Appendix 11

RESULTS OF CIRCULATION

Re: Region of Peel Comments 2036 Bovaird Drive & 10020, 10024, 10042, 10054 Mississauga Road Corbett Land Strategies Region File: RZ-23-010B City File: OZS-2023-0010

RE: Region of Peel Comments Zoning By-law Amendment 2036 Bovaird Drive & 10020, 10024, 10042, 10054 Mississauga Road City of Brampton Glen Rouge Developments Inc. Regional File: RZ-23-010B City File: OZS-2023-0010

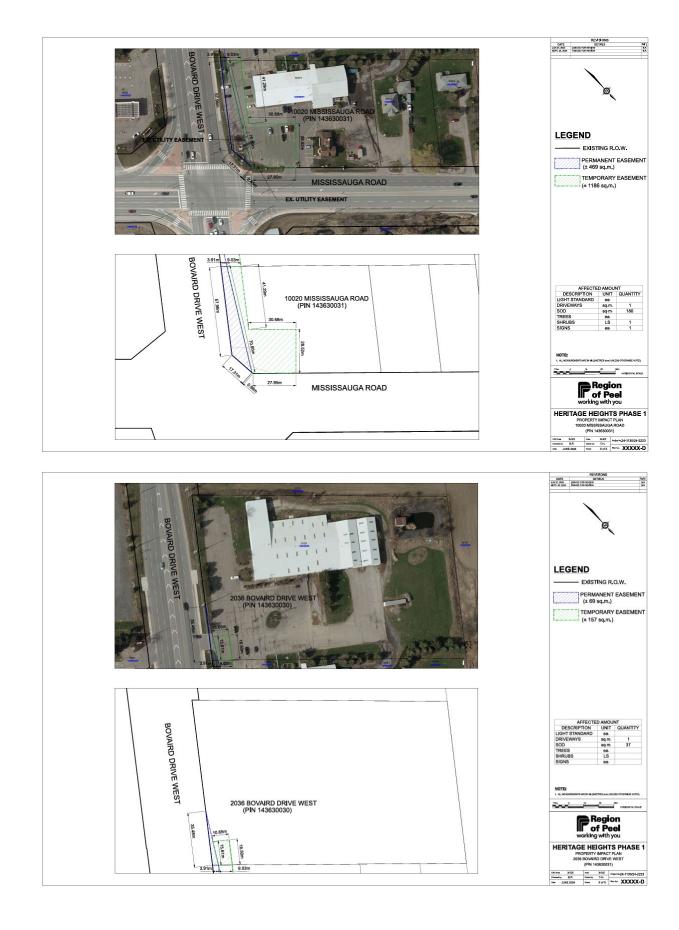
- Based on EA designs of the future widened Mississauga Road and Bovaird Drive intersection, a reverse taper with a roll-over curb for the transition between the auxiliary right turn lane and the bus bay is required for the proposed private access along Bovaird Drive as a future bus bay will be installed closer to the intersection.

- The Region requests that a functional design be included as part of the next submission which addresses auxiliary turn lane requirements and geometrics for any and all accesses proposed off a Regional Road. Please include the proposed taper and storage lengths.
